NP-11-0014
May 13, 2011

Subject: Exelon Nuclear Texas Holdings, LLC
Victoria County Station Early Site Permit Application
Response to Request for Additional Information Letter No. 06
NRC Docket No. 52-042

Attached are responses to NRC staff questions included in Request for Additional Information (RAI) Letter No. 06, dated March 31, 2011, related to Early Site Permit Application (ESPA), Part 2, Sections 02.04.04 and 13.03. NRC RAI Letter No. 06 contained twenty (20) RAIs. This submittal comprises a partial response to RAI Letter No. 06, and includes responses to the following seventeen (17) Questions:

Figure 1. Time History of Water Level at the Southwestern Corner of the Security Wall for Manning's n Sensitivity Test (The water level for $n=0.03$ is the same as SSAR Figure 2.4.4-21, and the starting time is arbitrarily selected.)

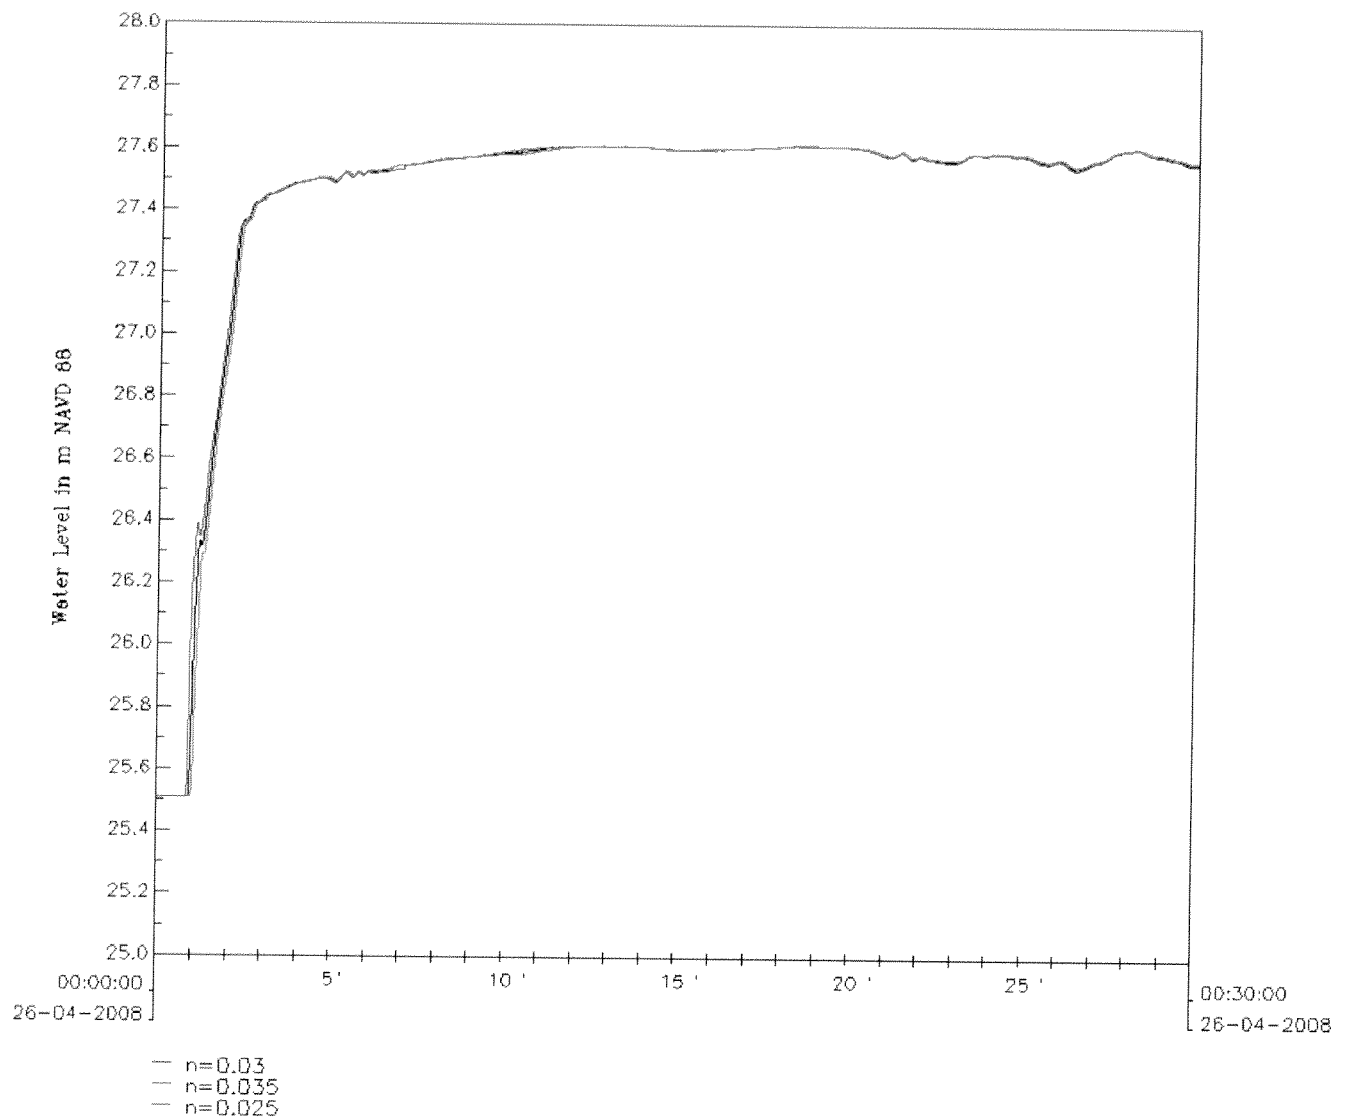
The staff has reviewed the application in accordance with the requirements of “Factors to be considered when evaluating sites” 10 CFR 100.20(c), and “Contents of application: technical information in the final safety analysis report” 10 CFR 52.79(a). The application does not provide detailed information discussing the cooling basin pool elevation selected for analysis and does not provide the background on the selection of the Manning’s n . Please provide additional information showing the selection of the cooling basin initial water surface elevation and the selection of Manning’s n in the vicinity of the breach, where applicable, considering that there are more conservative assumptions available.

As described in SSAR Subsection 2.4.4.2.2.5, the Manning’s n for the Cooling Basin (CB) breach analysis was selected based on the suggested values in SSAR Reference 2.4.4-14. The selected Manning’s n of 0.030, the normal value of the suggested range with a minimum of 0.025 and a maximum of 0.035, corresponds to flood plain type of terrains occupied by pastures with short grasses, which is comparable to the general characteristics of the existing conditions at the power block area and vicinity. After construction, the ground between the CB and the power block would consist of paved areas, such as parking lots (see SSAR Figure 1.2-2), and gravel/grass covered areas, with lower surface roughness. For example, the suggested Manning’s n values range from 0.013 to 0.016 for asphalt lined channels and 0.022 to 0.033 for engineered channels with gravel and grass covers (SSAR Reference 2.4.4-14). To address the differences in the surface roughness and potential impact on flow resistance, a sensitivity analysis was performed, as discussed in SSAR Subsection 2.4.4.2.2.5, to evaluate the effect of the Manning’s n on the flood water level at the power block area. Manning’s n values of 0.025 and 0.035, which correspond to the minimum and maximum values of the suggested roughness of the existing terrain, were tested and the results show that the flood water levels at the power block area are not sensitive to the Manning’s n values as shown in Figure 1.

Figure A-1

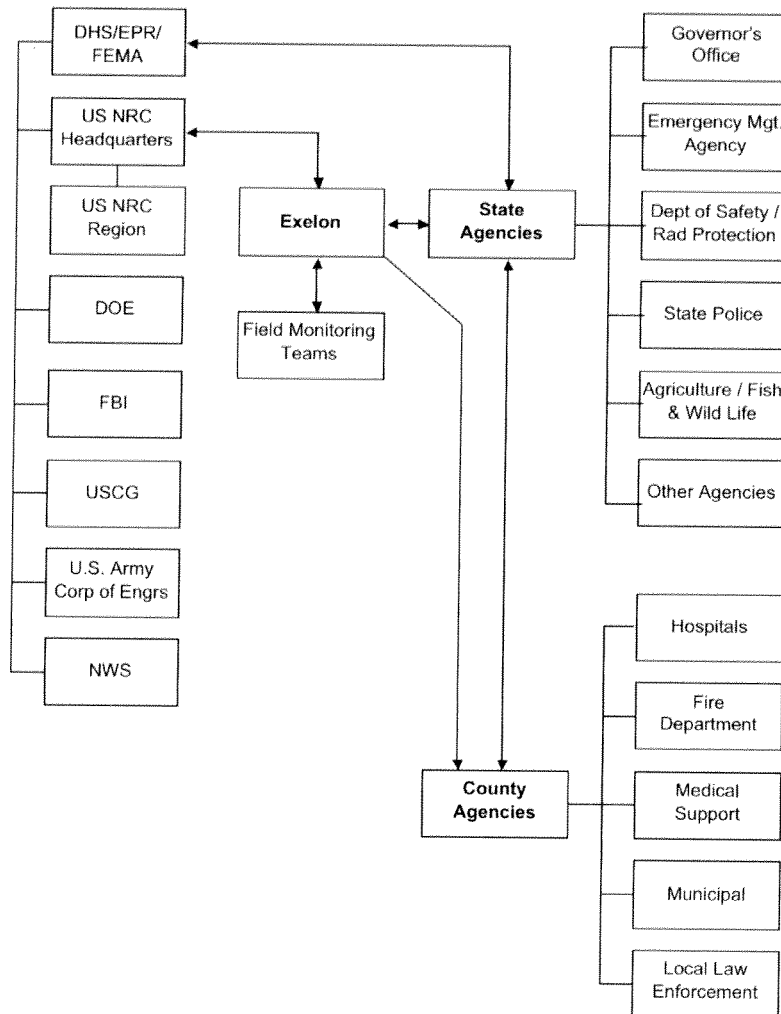
- RAI A-7. Include the Department of Homeland Security (DHS) in Figure A-2 of the Exelon Nuclear Standardized Radiological Emergency Plan, "Agency Response Organization Interrelationships" or justify why this is not necessary.
- RAI A-8. Section A.3 of the Exelon Nuclear Standardized Radiological Emergency Plan, "Agreements in Planning Effort," explains that written agreements have been developed that establish the concept of operations between the applicant and other support organizations having an emergency response role. Provide copies of the Letters of Agreement established with local support agencies in the Emergency Plan or Annex, or describe where these documents are maintained.

- RAI A-7 Figure A-1 in the VCS Annex has been revised to replace FEMA with DHS/EPR/FEMA.
- RAI A-8 The Letters of Agreement obtained during the development of this Annex are provided in Attachment 18.
- Victoria Fire and Rescue – fire protection and ambulance response.
 - The Victoria County Sheriff's Office – law enforcement.
 - Citizens Medical Center – medical services.
 - DeTar Hospital Navarro – back-up medical services
 - Victoria County – EOF and JIC location
 - Crossroads Chapter Red Cross – congregate care facilities.

Figure 4-1: Victoria County Station PAR Determination Flowchart

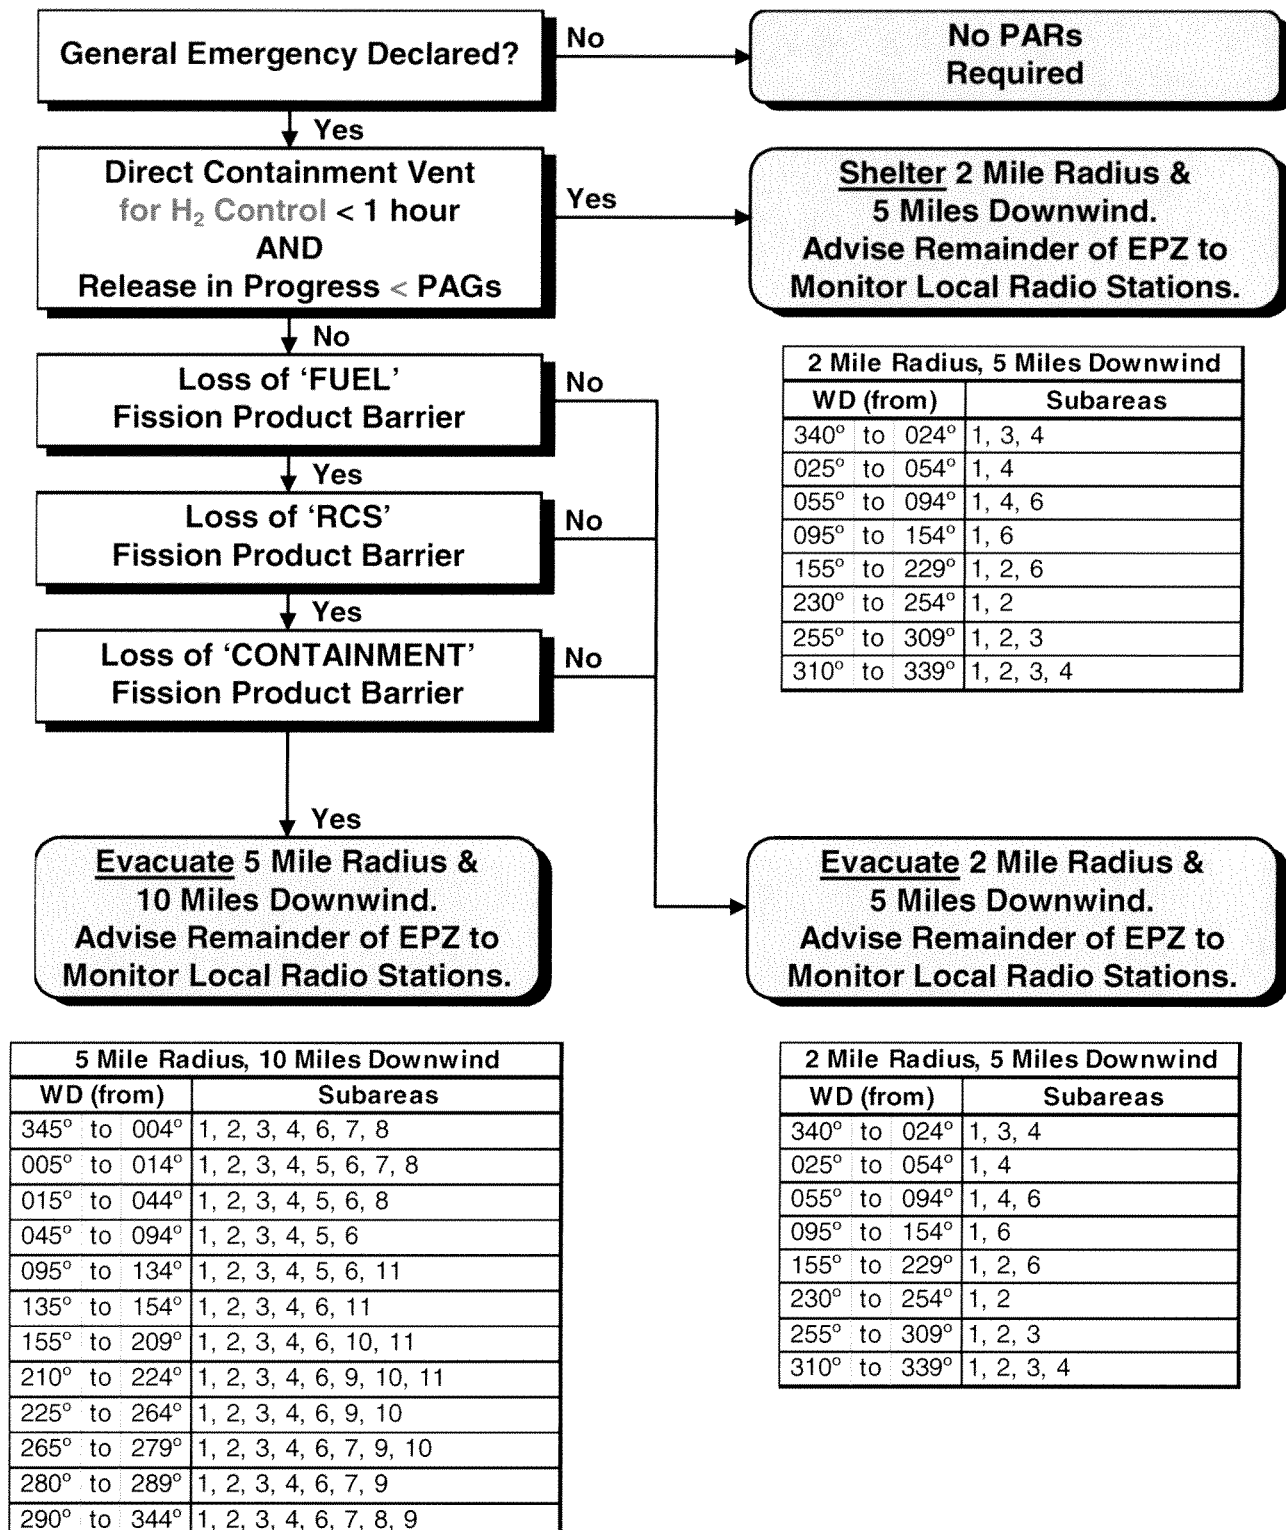
- RAI J-5. Figure 4-1, "Victoria County Station PAR Determination Flowchart," of the Victoria Annex provides the steps considered in making the PAR determination. Explain in the Annex how the Evacuation Time Estimate is used in conjunction with PARS to develop the evacuation plan or justify why this is not necessary.

RAI J-5: NUREG-0654, Supplement 3 provides guidance on the issuing of Protective Action Recommendations (PARs) for the general public. Unless determined by Exelon during a declared General Emergency that the release of radioactive material is a "puff release" the ETE will not be considered when making protective action recommendations. The Plant operators may not have information regarding the environmental concerns regarding the off-site areas surrounding the site. The county or state officials will take into consideration the ETE for the current environmental conditions and make a decision to utilize the VCS PARs or to modify them based on additional information that they have concerning the evacuation routes.
